We thank anonymous referee #1 for evaluating our manuscript and for the very useful comments, which we treat in the following item-by-item. In this author's comment, the points as raised by the reviewer are replicated in blue text, along with the corresponding reply from the authors in black text.

Manuscript continues series of papers devoted to the development of the COCCON network which is based on EM27/SUN FTSs (Fourier transform spectrometer) observations. This type of FTS designed by KIT in close collaboration with Bruker Optics has a number of unique characteristics including portability, robustness, and ease of use. The combination of EM27/SUN FTS together with the state-of-the-art open-source codes (PREPROCESS and FROFFAST) designed at KIT for processing of interferograms and spectra allows provision the highest accuracy/precision values of atmospheric XCO2, XCH4, XH2O and XCO. Since 2014, EM27/SUN spectrometers have been successfully tested in various kinds of environments including a number of intensive field campaigns. The COCCON community is growing rapidly, therefore one of most important tasks is to develop tools to ensure rigorous QA/QC throughout the network. Namel

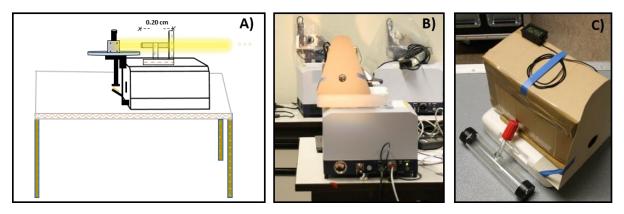
Figure 1: In addition to the existing panels it would be helpful providing an extra panel with the side view on the set-up for open-path measurements.

Lines 131-132: "The spectrometer is now oriented in such a way that the cell can be conveniently located in the infrared beam on top of the spectrometer housing (see Figure 1 and Figure 4 A).": This is not clear from the photos in Fig.1 and Fig.4A where/how the cell is placed.

Thanks for the suggestion, we have added the following figure:

Figure 4 was updated with the side-view of the set-up, based on Figure 1, to better show the way how the cell is mounted on the cover of the spectrometer.

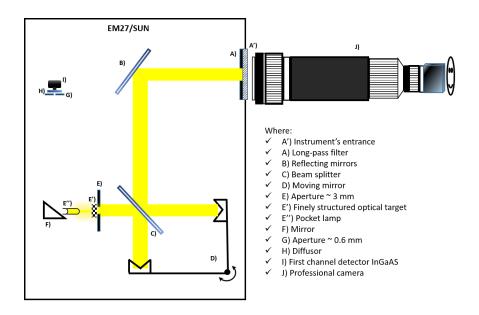
Line 138-139: The term "instrument entrance" is not mentioned/presented in the list in Figure 2, so it is unclear which path (inaccessible) is being measured.

Fig.2: It would be helpful to indicate the position of an fine optical target in Fig.2.

The figure has been replaced by the figure below. The instrument's entrance window (we assume that this location is defined by the long-pass filter integrated in the cover of the spectrometer) and the position of the aperture stop inside the spectrometer are now clearly marked to avoid confusion.

The figure has been updated in this respect also and now contains the position of the illuminated target (which coincides with the aperture stop of the interferometer).
